ALNRC 00007.

NRC PROJECT #750
AMERENUE – CALLAWAY PLANT UNIT 2
SUBMITTAL OF SUPPLEMENTAL INFORMATION FOR THE CALLAWAY
PLANT UNIT 2 COMBINED LICENSE APPLICATION

**Supplement to FSAR 2.5 and 2.5.1;
Expanded Geologic and Tectonic Descriptions**

Figure 2.5-147, {Regional Gravity Anomaly Map}

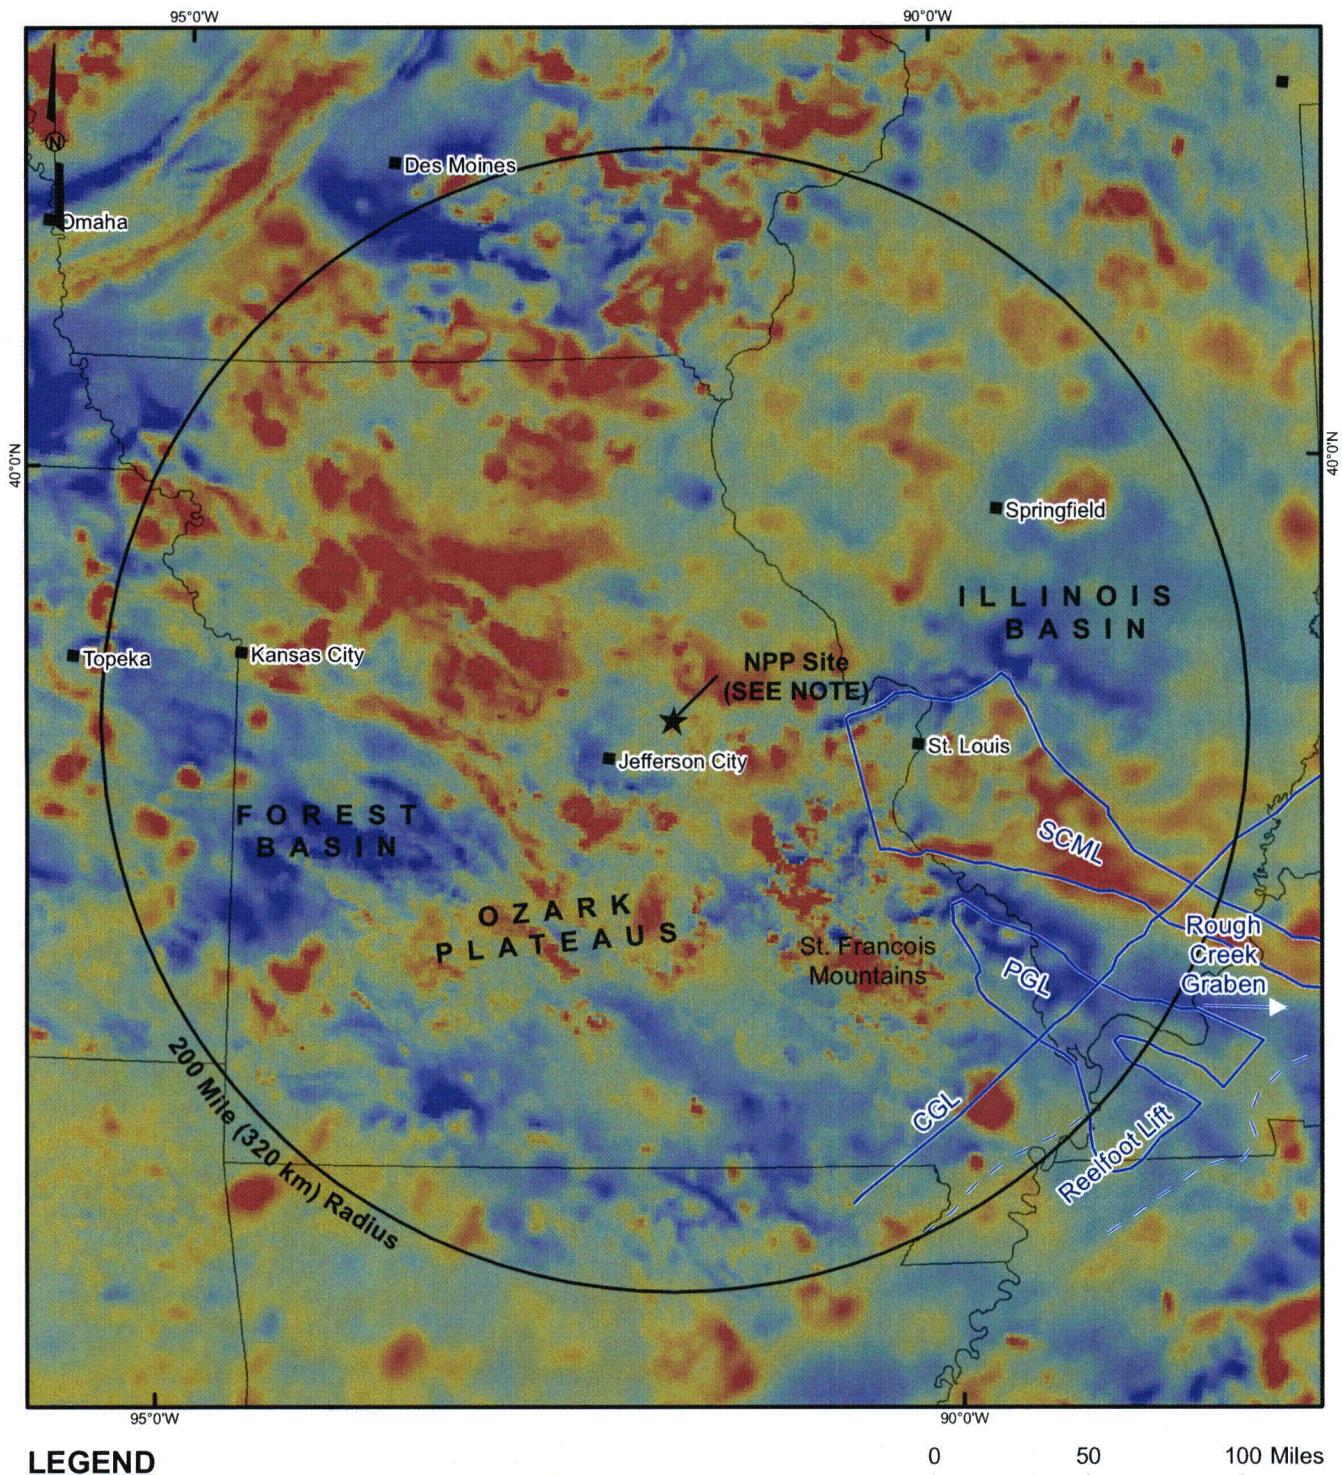
The New Madrid seismic zone Bouguer anomaly map on Figure 2.5-147 reflects the seismic feature parallel to the Reelfoot Rift and suggests its close relation with the Reelfoot Rift as illustrated on Figure 2.5-148 (Regional Gravity Anomaly Map with Earthquake Overlay) which overlays the epicenters in the region on the gravity data shown on Figure 2.5-147. This Figure 2.5-148 shows that the gravity anomaly is associated with the earthquake activity in the Reelfoot Rift, Mississippi Embayment, and the Illinois-Indiana border, south of the Illinois Basin.

The maps on Figure 2.5-147 and Figure 2.5-146 show a belt of linear, but discontinuous gravity highs, with several positive aeromagnetic anomalies in the eastern part of the region of the site—well removed from the site. Positive gravity anomalies in the Mississippi Embayment are interpreted to be caused by high density rocks beneath the embayment that were emplaced during the late Pre-Cambrian to early Paleozoic rifting event or during Mesozoic reactivation of the rift.

Figure 2.5-149, {Quaternary Class "A" Features in the CEUS}

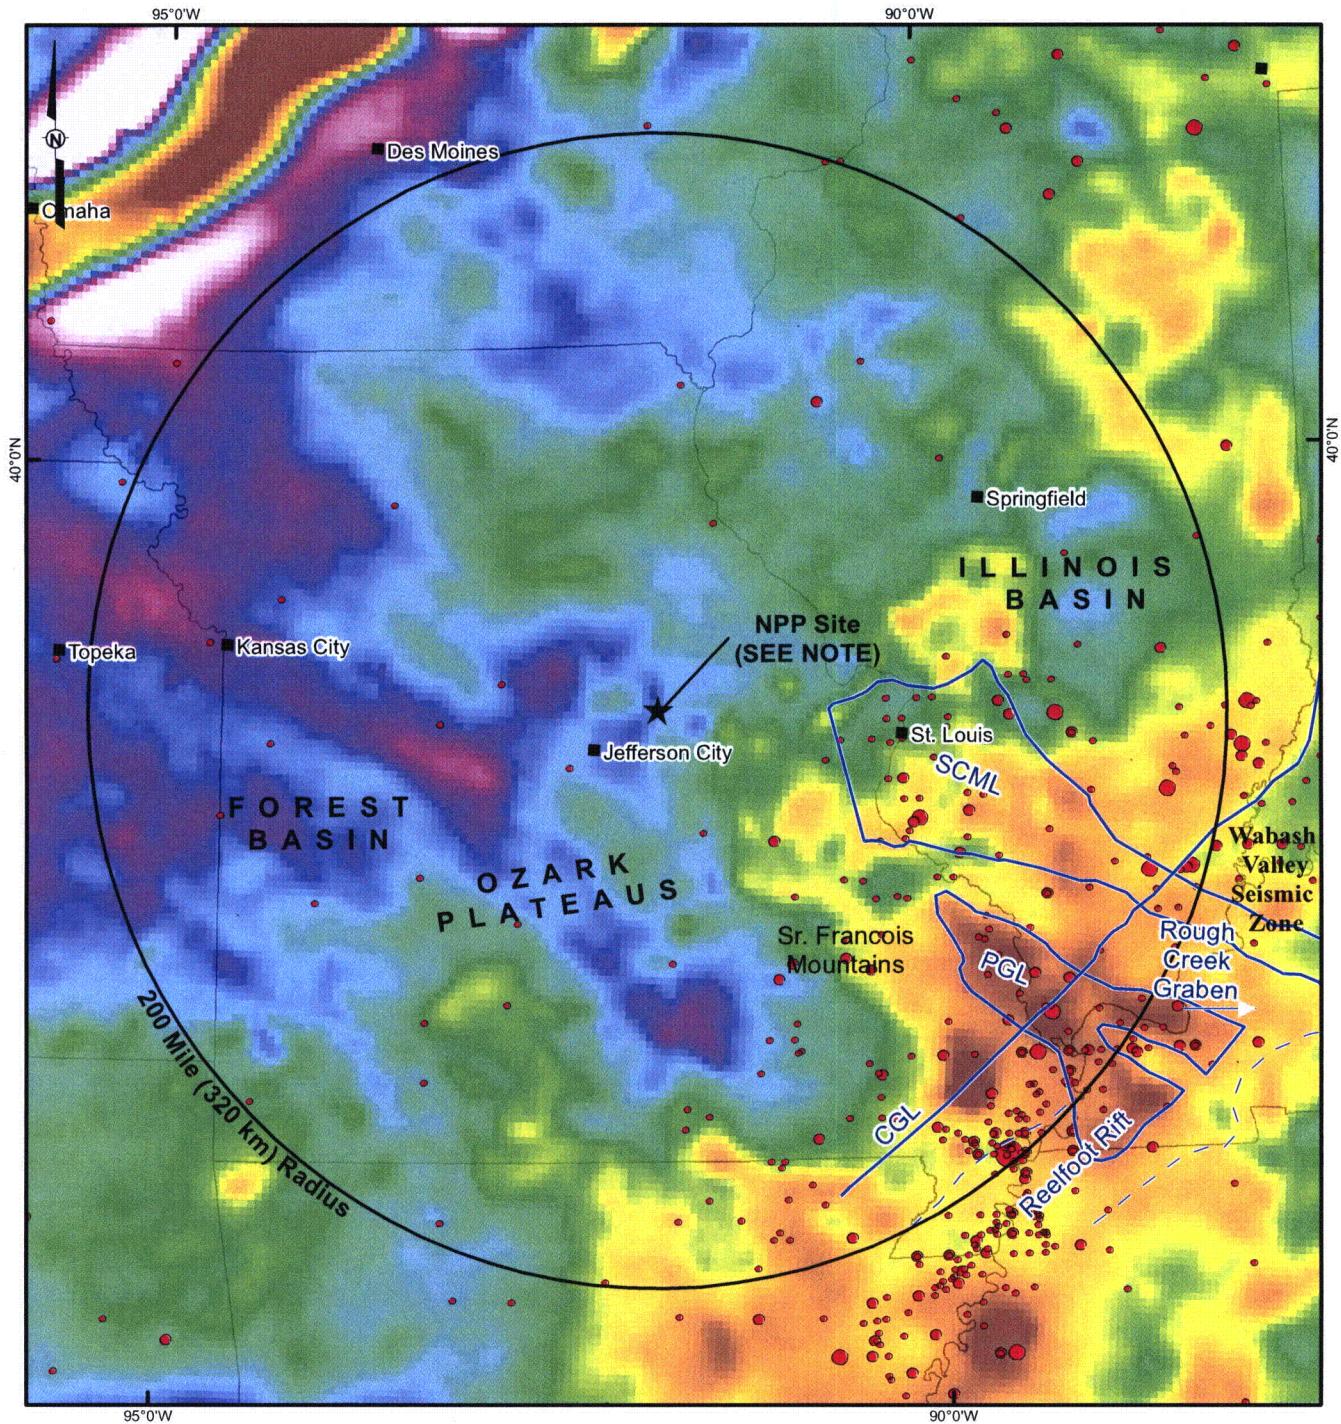
Three Class "A" features in Crone, 2000 were included in this section: the Faults of Thebes Gap Area (Missouri, No 6 in Figure 2.5-149), the Western Lowlands liquefaction features (Missouri-Arkansas, listed as No 3 in Figure 2.5-149), and the St. Louis-Cape Girardeau liquefaction features (Missouri-Illinois, listed as No 4 in Figure 2.5-149), were included in this section. Also included is the Slinkard Quarry Graben (Wheeler, 2005), a Class "A" feature within the city limits of Cape Girardeau, Missouri.

The individual named faults discussed here are not sections of a single long fault. Instead, they are individual strands in a fault complex, shown as feature No 6 in Figure 2.5-149 (Crone, 2000). They have different strikes, dips, slip senses, and slip histories, where individual faults in the fault complex, and the longest faults, strike northeasterly to north-northeasterly, but numerous shorter cross faults strike easterly and northwest (Crone, 2000)

The Western Lowlands of Missouri and Arkansas form the part of the northwestern Mississippi embayment that lies west of the uplands of northeast-trending Crowley's Ridge, shown as feature No 3 in Figure 2.5-149 (Crone, 2000). Several prehistoric liquefaction features west of Crowley's Ridge are here informally grouped under the name Western Lowlands. The liquefaction was recognized as the type that is caused by strong ground motion and the strong motions are presumed to have been caused by slip on one or more preexisting faults. However, the causative faults have not been identified and the locations and sizes of the liquefaction features identified to date provide poor constraints on the sources of the shaking.
